CEC submission for Vivian Silica Sand Extraction Project

D.M. LeNeveu, M.Sc. (biophysics). B.Sc. (honours physics), B.Ed.

Feb. 13, 2023

Figure 10. Sio Silica air lifting well at Center Line Road for advanced exploration. Illustration is by D.M. LeNeveu. Image of well was used with photographer’s permission.

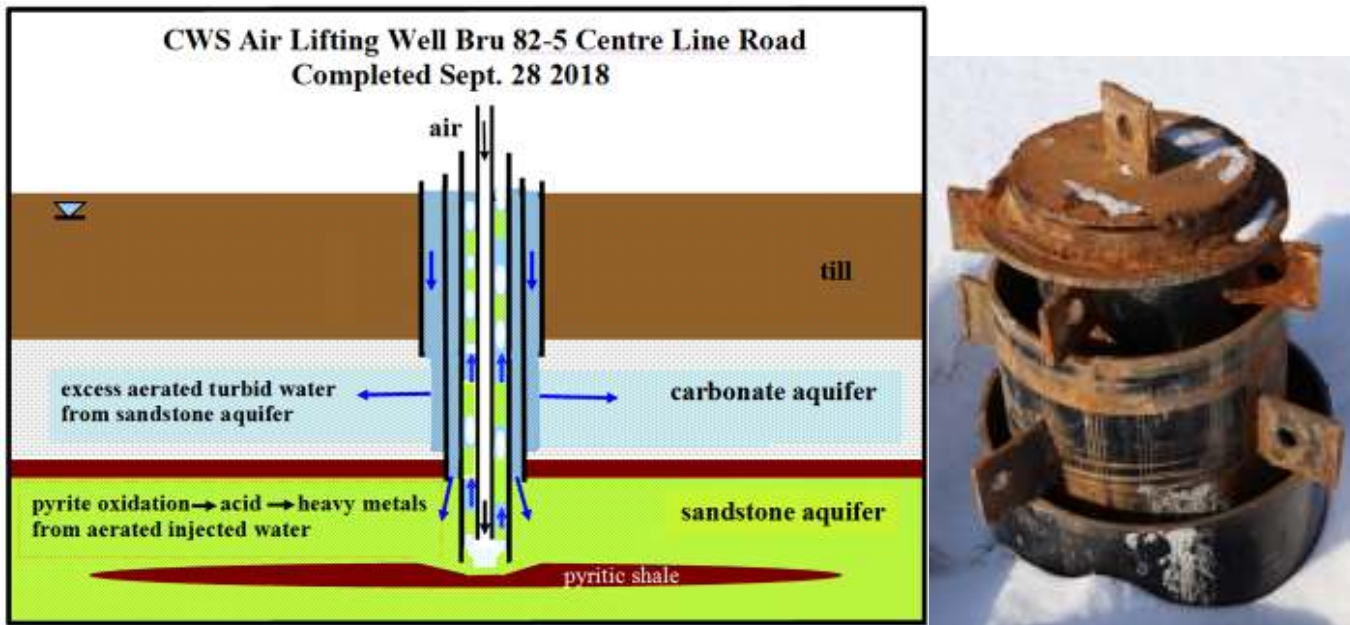
82-6/BH47-18 completed Sept 28, 2018 and Nov.14, 2018 were concentric triple tube wells with the outer steel casing opening into the carbonate, the middle steel casing opening into the top of the sandstone and a deeper steel casing opening into the sandstone. The well construction of Bru 82-5 and the possible water re-injection and sand extraction routes is shown in figure 10. The air injection tube in the centre would be removable thus is not shown in the photograph of the well on the right. Bru 82-5 was sealed and cut off at two feet below ground surface on June 18, 2020, almost two years after completion. It should be noticed that well Bru 82-5 is one of many Sio Silica advanced exploration wells left open at the surface for long periods before sealing in violation of Manitoba groundwater regulations.

Figure 11. CWS permitted injection well Bru 92-8 at a quarry south west of Vivian 2021. Illustration is by D. M. LeNeveu. Well information report was from Manitoba Groundwater

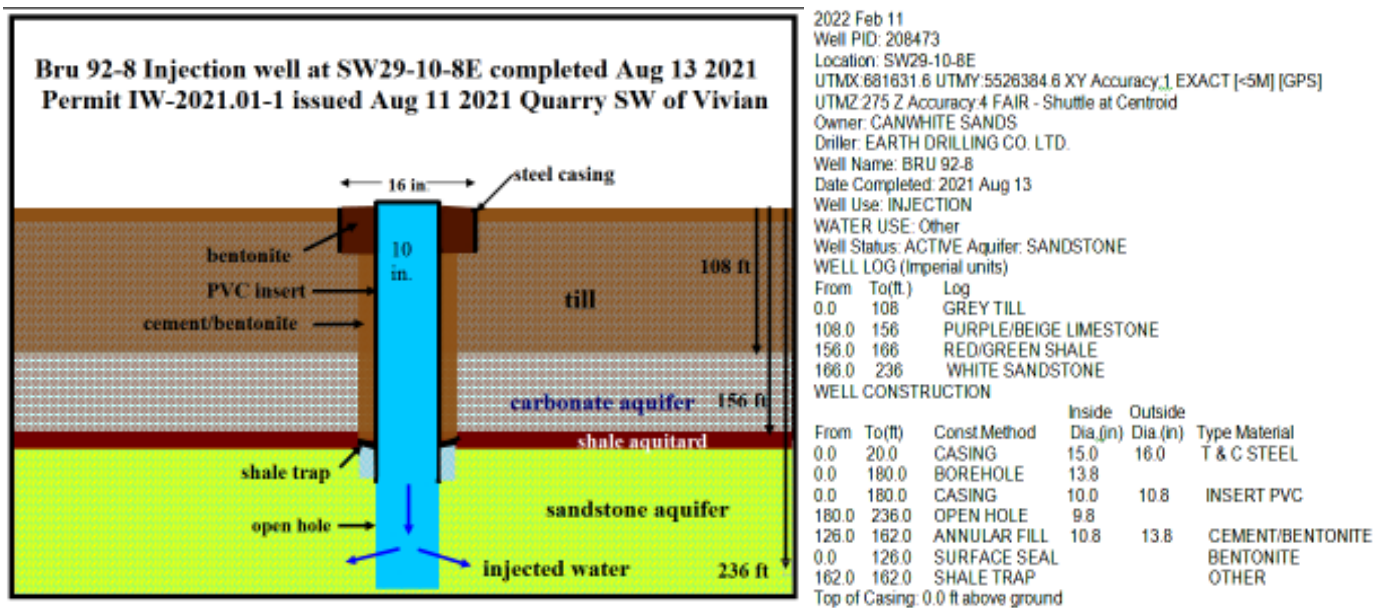
Figure 11 shows that the permitted injection well Bru 92-8 at the quarry south west of Vivian. Injection well Bru 92-8 is missing the production pipe and therefore does not conform to the Sio Silica design in the EAP. Sio Silica has explained in the response clarification of the DLN Information Requests (IR) that the production tube was removed even though the well construction reports obtained from Manitoba Groundwater do not record the installation and removal of the production tube. The procedure for injection of water through a removal production tube remains unclear. There is no stated means to stabilize the production tube within the outer PVC annulus shown in figure 11 for Bru 92-8. Any well inserts to prevent the production tube from moving during sand extraction and water re-injection could interfere with the water re-injection.

Figure 12. Bru 92-2 production well completed July 11, 2021 at a quarry south west of Vivian. Illustration by D.M. LeNeveu was based on the well information report received from Manitoba Groundwater shown on right. Photograph of well Bru 92-2 was reproduced with permission of photographer.

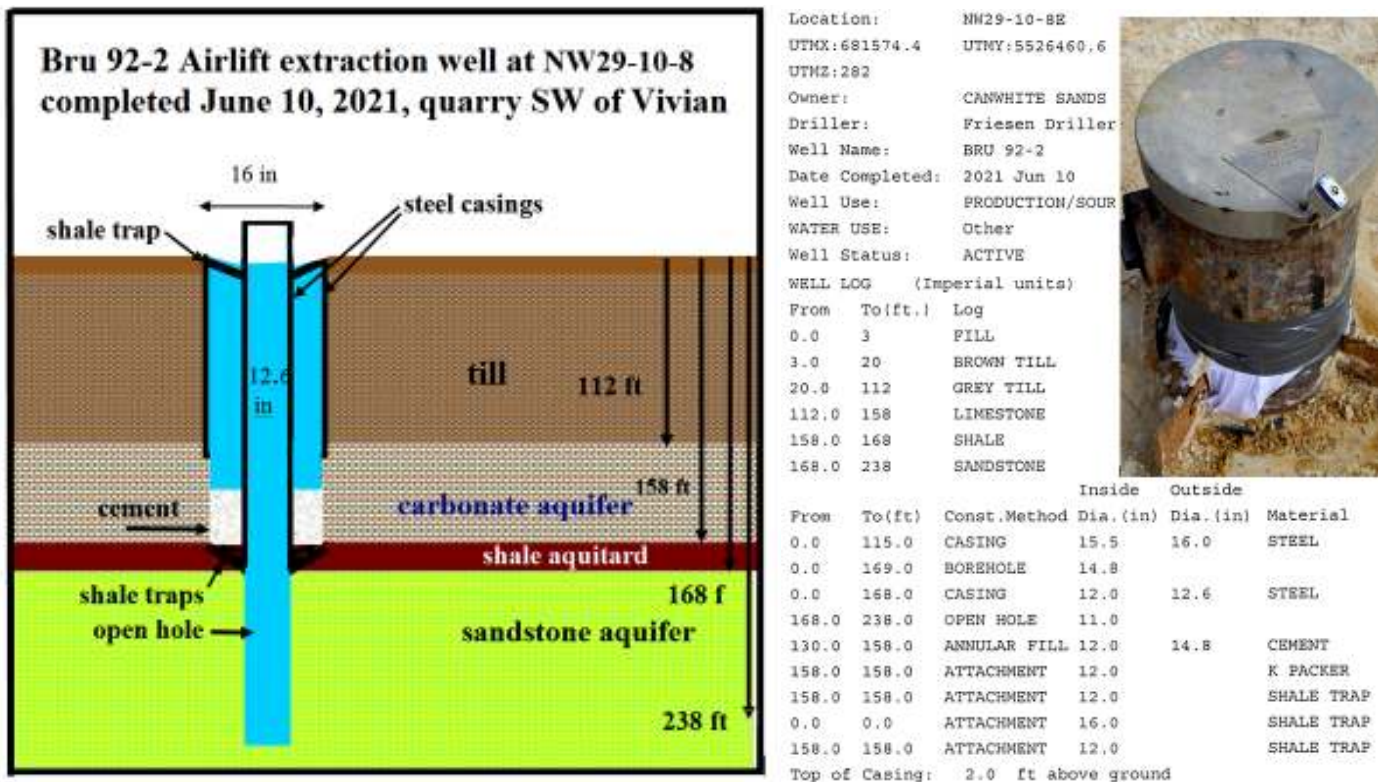
taken from the sandstone aquifer is prohibited by Manitoba regulations. In addition Bru 92-2 is not permitted as an injection well thus water could not be re-injected in this well even though the well is designed for re-injection into the carbonate. The opening into the carbonate is protected at the surface with a shale trap. This is not a permanent seal. I must question why temporary shale trap would be used to seal the surface opening directly into the carbonate aquifer. A cloth skirt was affixed around the well with duct tape as shown in figure 12 for what purpose? If a permanent seal is not placed to seal the opening in the outer annulus into the carbonate aquifer contamination could eventually occur from ingress of contaminated surface water.

Figure 13. Bru 92-3 production well completed July 11, 2021 at a quarry south west of Vivian. Illustration by D.M. LeNeveu was based on the well information report received from Manitoba Groundwater shown on right. Photograph of well Bru 92-3 was reproduced with permission of photographer.

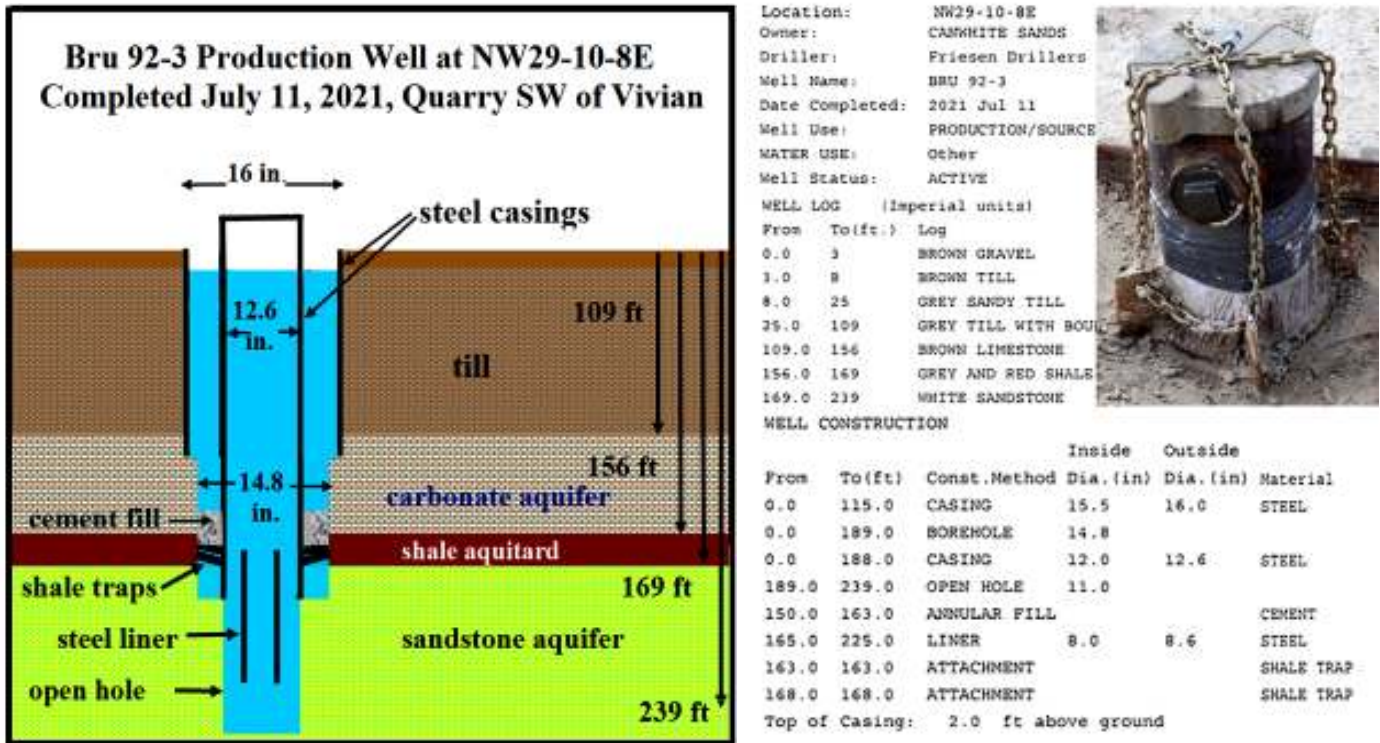
Figure 13 for Bru 92-3 has steel liner penetrating into the sandstone and no sealing of the outer annulus.

This remark explains why the central steel liner appears to be unsupported in the illustration in figure 13.

Figure 14. Drawing from Sio Silica airlift patent application. Drawing was reproduced from the Sio Silica patent.¹

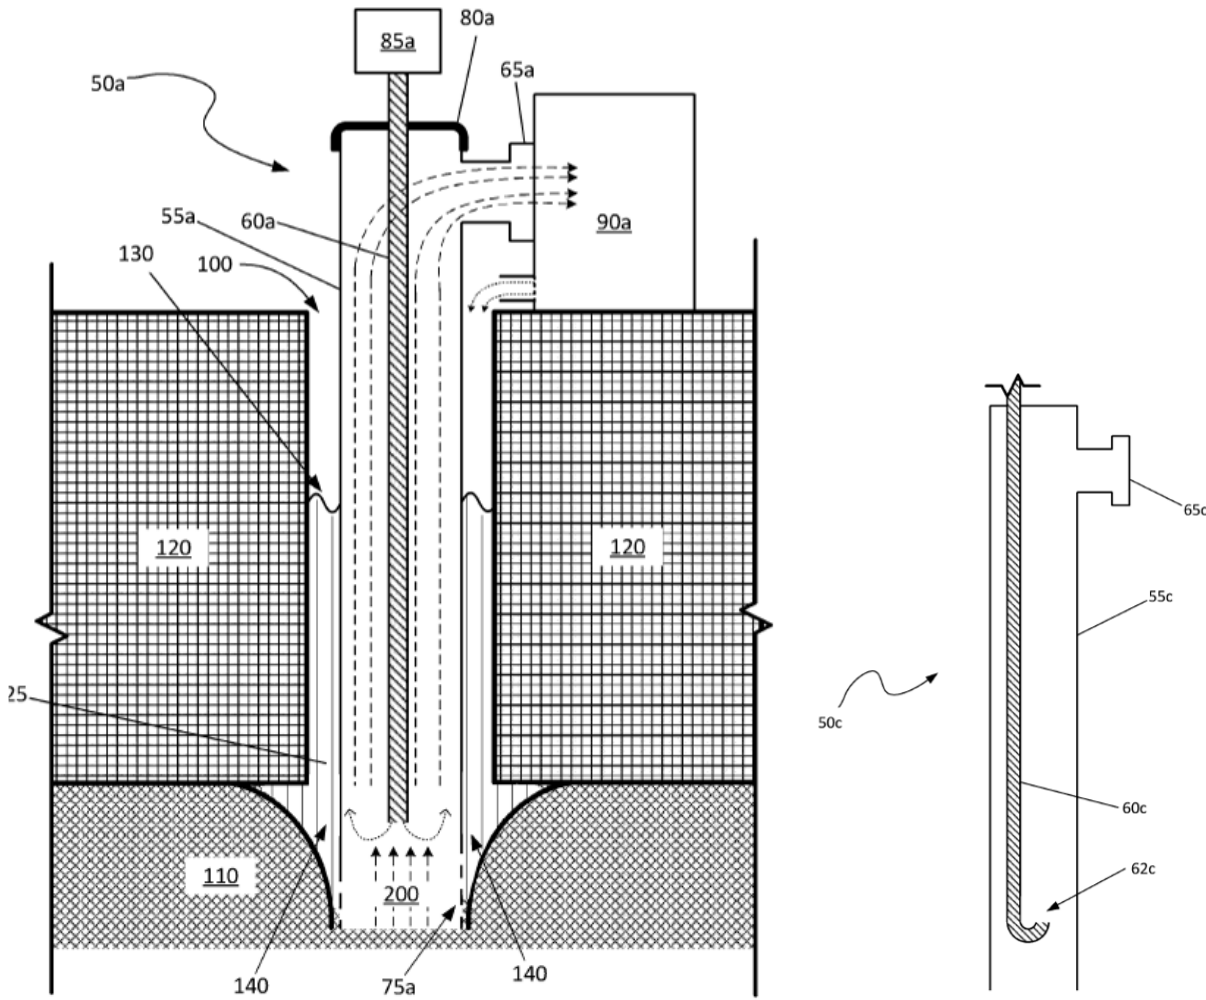
Figure 14 shows the water barrier “140” formed from re-injected water around the withdrawal well inhibiting sand removal. The height of the re-injected water column labelled “130” in figure 14 is maintained to provide re-injection pressure.

Figure 14 illustrates that there will be a drawdown of the water level in the outer annulus used to return water caused by the suction of the air lift. The height of water in a tank or vessel at the surface draining returned water into the aquifer will provide a gravity pressure head helping to move water into the aquifer. This would be similar to the gravity pressure head forcing water down the drain in a bathtub from the height of water in the tub. It has not been demonstrated during production with many extraction wells operating simultaneously that a gravity fed water return would be able to keep pace with the amount of water withdrawn with the sand. Sio Silica has refused to measure the pressure from water re-injection that is a requirement of the injection well permit stating that no pressure is used to force the returned water into the aquifer. The height of returned water in a surface tank above the drawdown level in the outer annuls however would provide a pressure that would be manifest in the aquifer.

Figure 16. Head Change contours from three Sio Silica extraction wells after one day of operation. Illustration from simulations by D.M. LeNeveu.

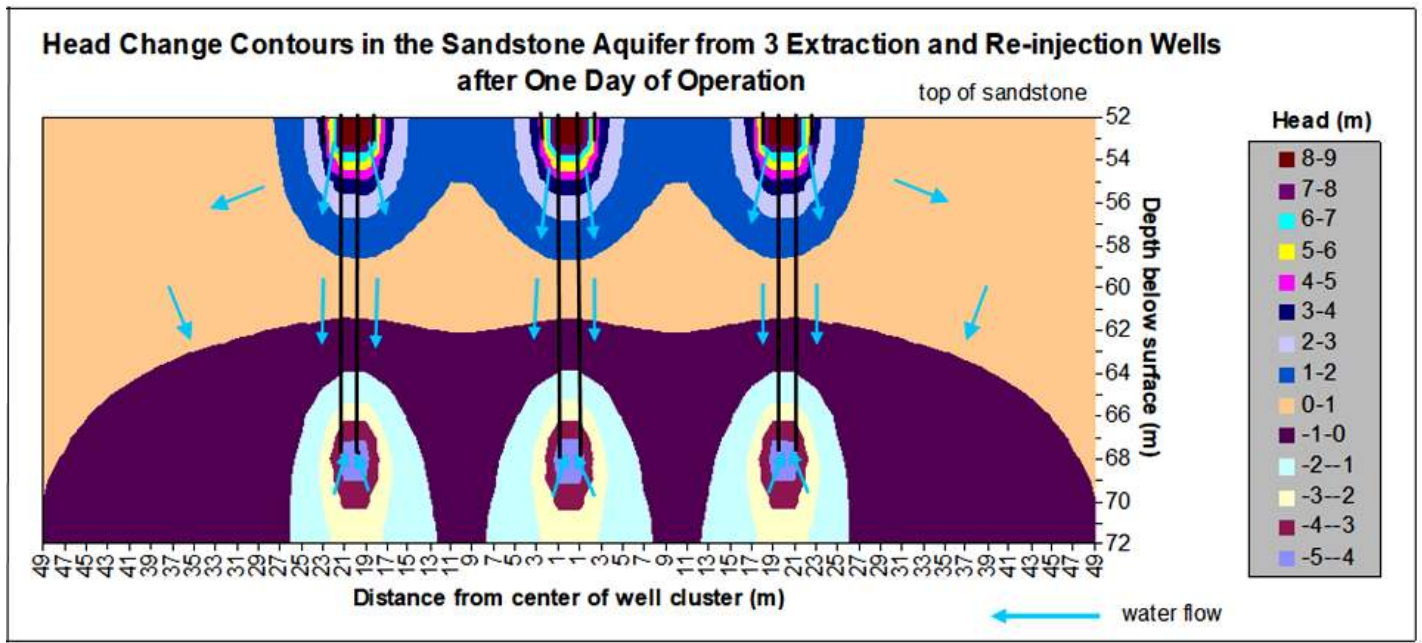
Figure 16 illustrates the head change from the re-injection and withdrawal of water for three production wells after one day of pumping. The water flow direction is perpendicular to the head contours.

The head gradients are largest next to the production tube thus the re-injected water concentrates around the tube as shown in figure 16. Results from the C&J solution verifies the description in the Sio Silica patent that the re-circulation of the re-injected water acts as a barrier to sand uptake.

Figure 16 shows that contrary to Sio Silica claims, pressure is exerted on the shale aquitard and the carbonate aquifer from the re-injection. It is important to understand the model input for the C&J solution is the withdrawal and injection rates not pressure. Thus pumping pressures are not required, only water injection and withdrawal rates. The positive pressure exerted by the re-injection is caused by the resistance to the movement of the injected water.

Figure 17. Head Change contours from three Sio Silica extraction wells after three hours of operation.
Source: simulations by D. M. LeNeveu.

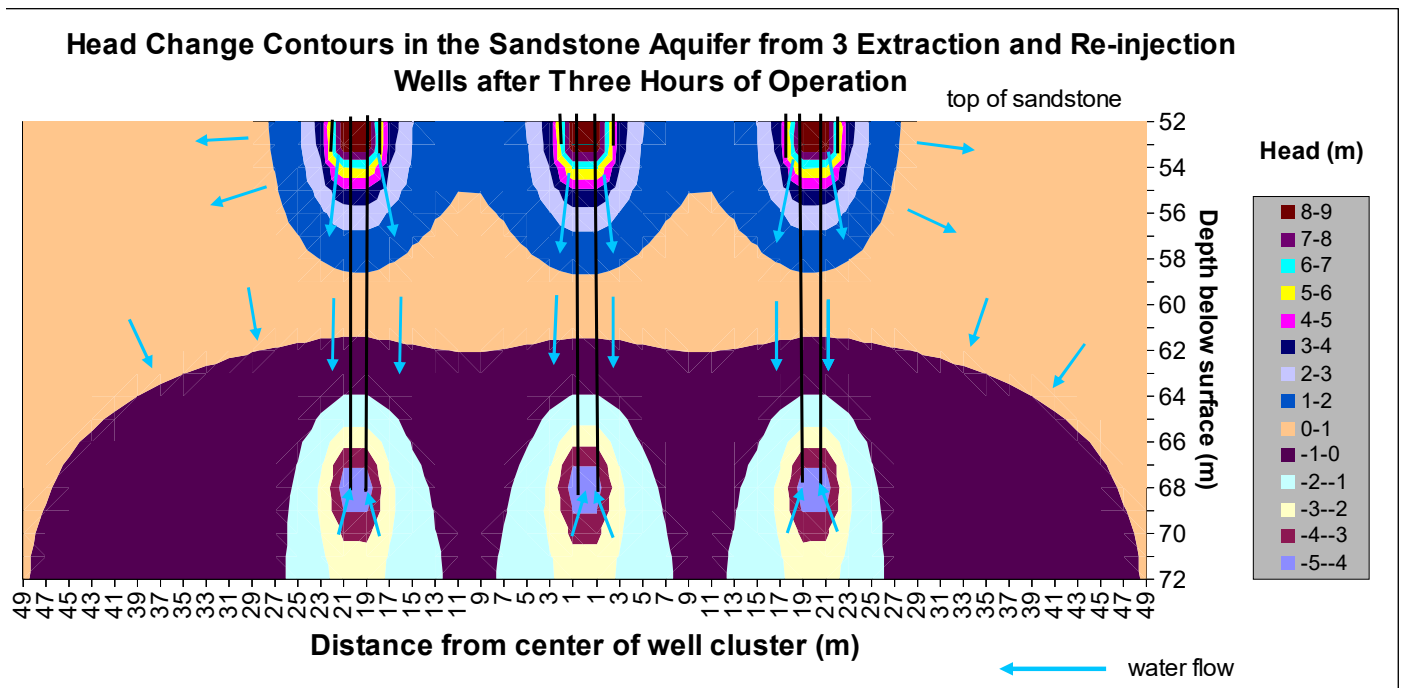
Figure 17 shows that after only three hours of operation the head change contours are virtually the same as after one day. Only a small decrease in the extent of the zero pressure head contour for three hours compared to one day of operation is visible. Steady state where re-injected water is simply being re-circulated is established very quickly. After the initial sand is extracted next to the well and a cavity (void) is formed around the well further uptake of sand is inhibited in less than 3 hours into operation.

Figure 34. Limestone thickness for the Sio Silica extraction area. Illustration from analysis by D. M. LeNeveu based on data from well information reports obtained from Manitoba Groundwater Section

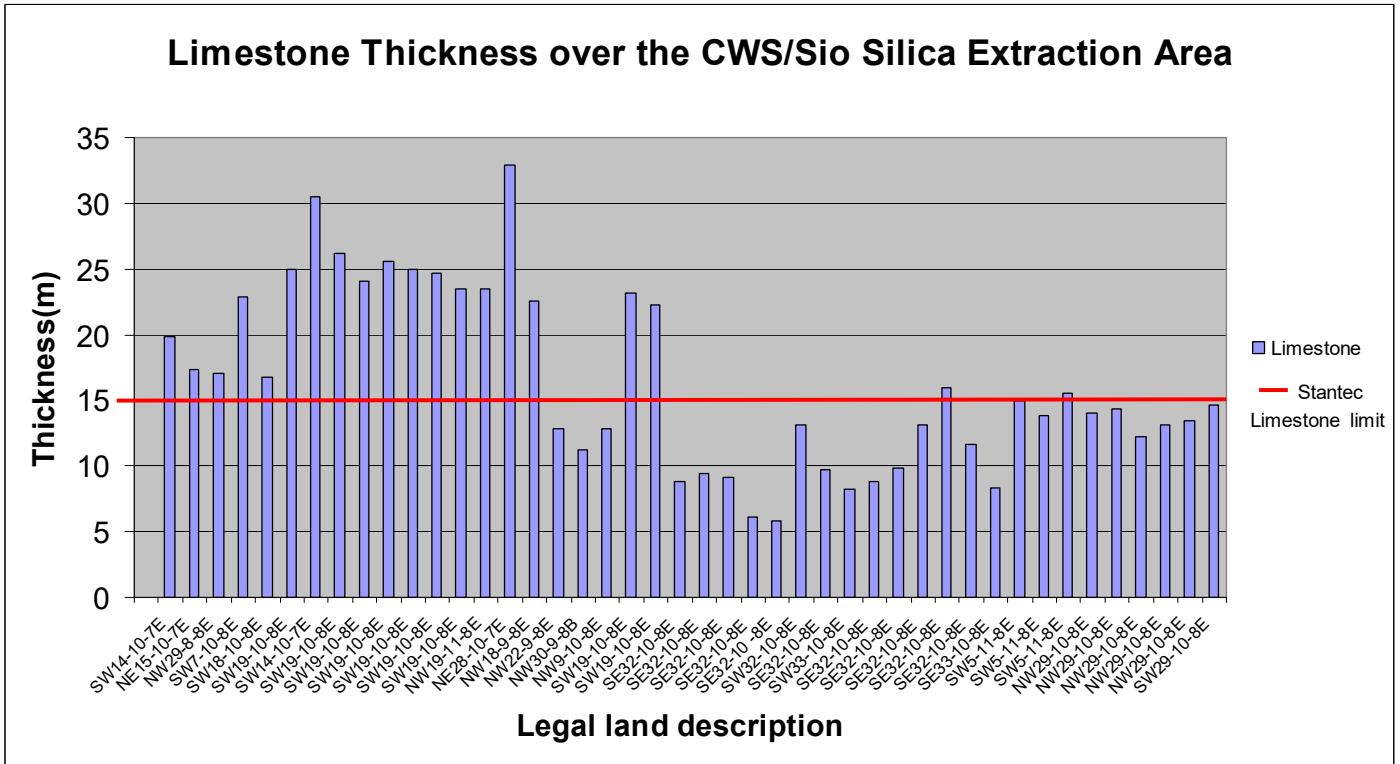
All limestone thicknesses less than 15 meters on the right of figure 34 are in the area east of highway 302. Thus according to the Stantec recommendation to; “Limit extraction areas with competent limestone thicker than 15 meters,” no extraction must occur east of highway 302,

Figure 36. Limestone and till thickness and maximum allowable long-term excavation cavity span over the Sio Silica 24 year project area.

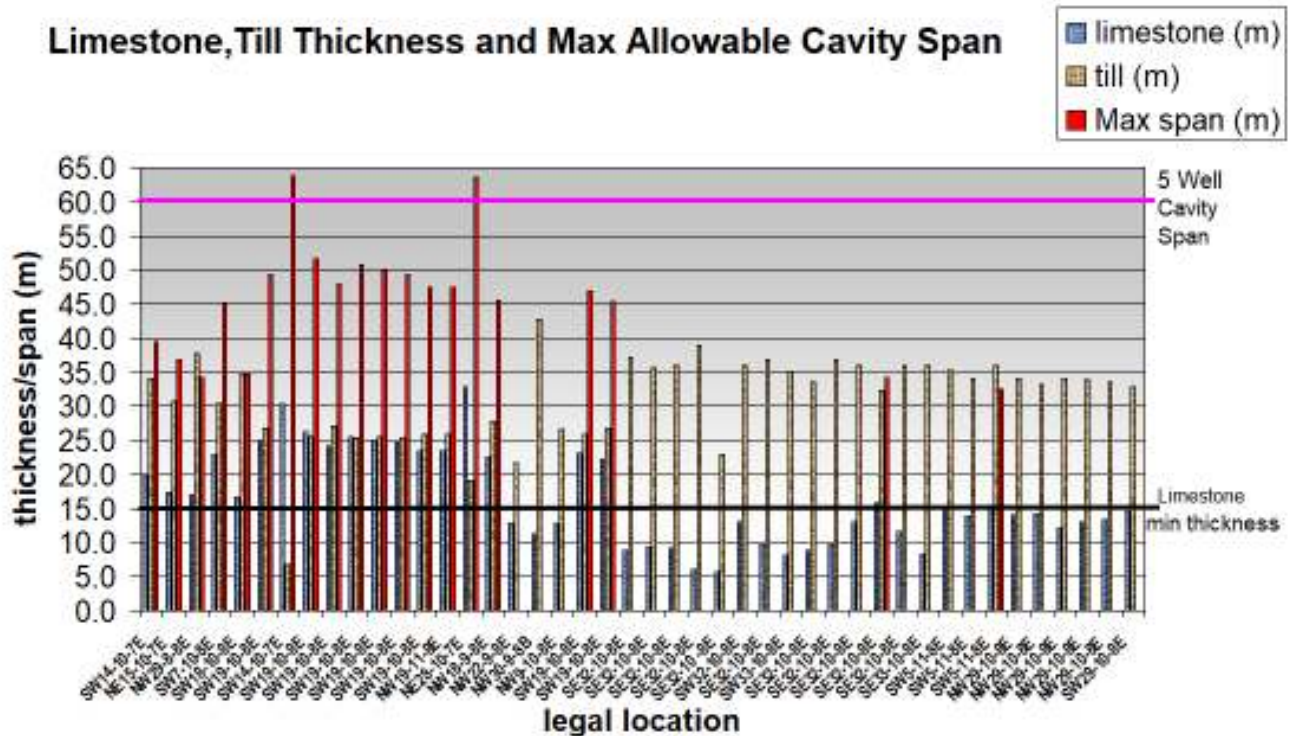
However except for two locations SW14-10-7E and NE28-10-7E both north of the aqueduct about half way between highway 302 and highway 12, the cavity span of 60 meters for 5 wells would be unstable. The limit of 15 meters for limestone thickness would render only 20 locations of the 44 viable. Therefore over most of the project area figure 36 demonstrates that extraction cannot occur.
